Building: Senior Citizen Center

Project Description: Replacement Senior Citizen Center Construction

**LEXINGTON-FAYETTE URBAN COUNTY
GOVERNMENT CONTRACT CHANGE ORDER**
Page 1 of 2

CHANGE ORDER NO. 40

1 DANCE STORAGE CEILING
 SKA-126 SCALE: 1/4" = 1'-0"

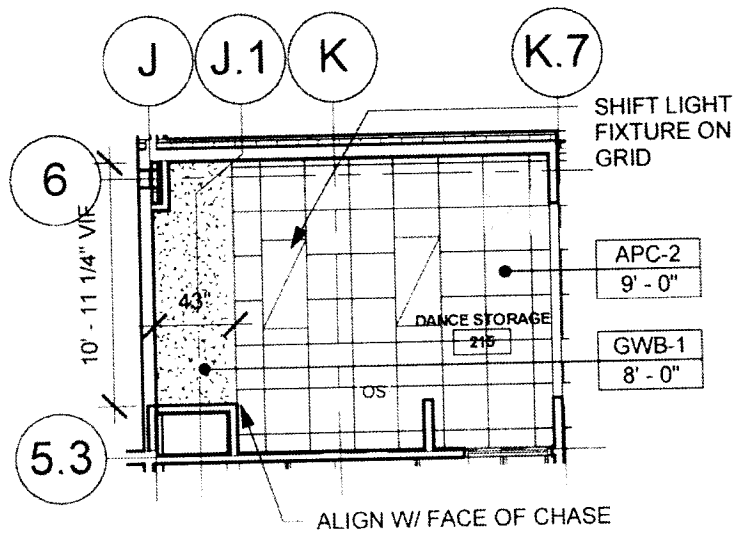
PR-75 Furnish a Painted GWB Soffit to Avoid the HVAC Ductwork Conflict in the Dance Storage Ceiling per Proposal Request No. 68

To avoid conflict with HVAC ductwork, please furnish a painted GWB soffit per the attached sketch. Please verify all dimensions prior to fabrication.

CA-FLOOR GRILLES AT PLATFORM

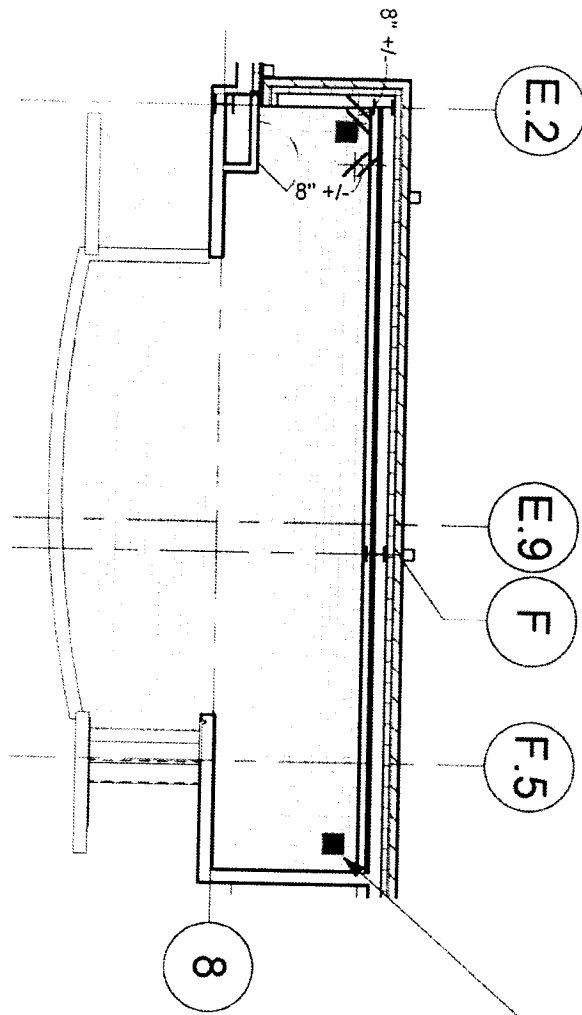
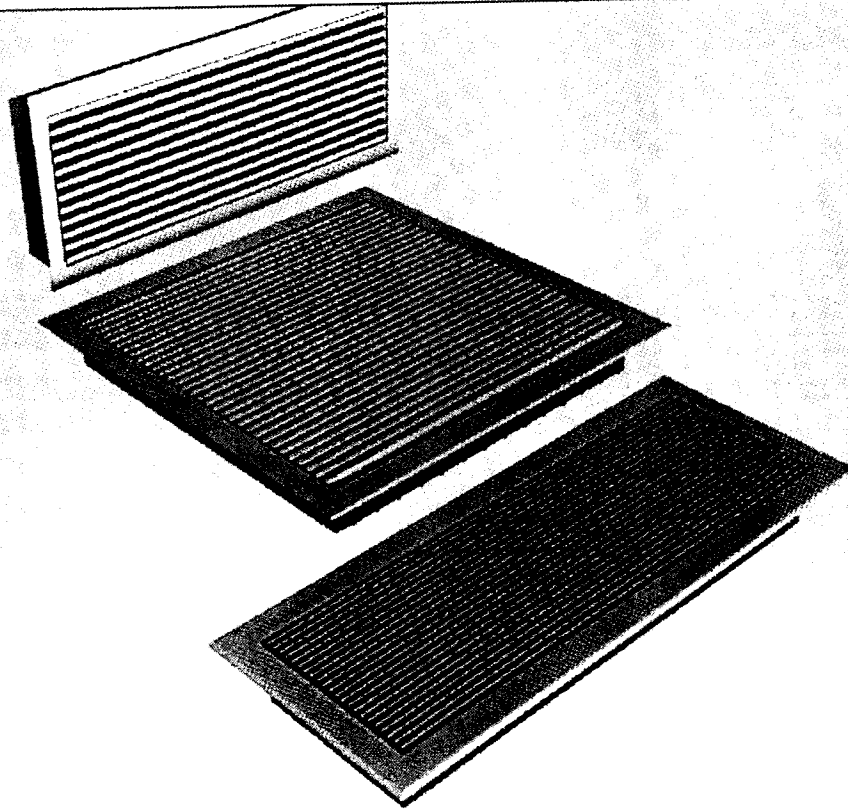
- Per recommendation from the flooring subcontractor, please furnish and install the following improvements for the platform flooring:
- Lay 20 mil minimum plastic nonwoven membrane sheet at the floor slab to inhibit moisture infiltration into the plenum
 - Install (2) displacement floor grilles as shown on the attached sketch for adequate air movement in the plenum. See basis-of-design product data in attached documents. Install blocking as required to adequately support floor grilles for normal traffic. Install between floor support studs; do not cut floor support studs to install (dimensions on the attached sketch are suggestions; locate as near

to this dimension without cutting studs).

DISPLACEMENT FLOOR GRILLE, TYP
 -INSTALL PER MANUFACTURER'S
 INSTRUCTIONS
 -WOOD BLOCKING AS REQUIRED TO
 MATCH ROUGH OPENING BETWEEN
 FLOOR SUPPORTS
 -FIN LAYOUT AND FINISH PER SPEC
 SHEET
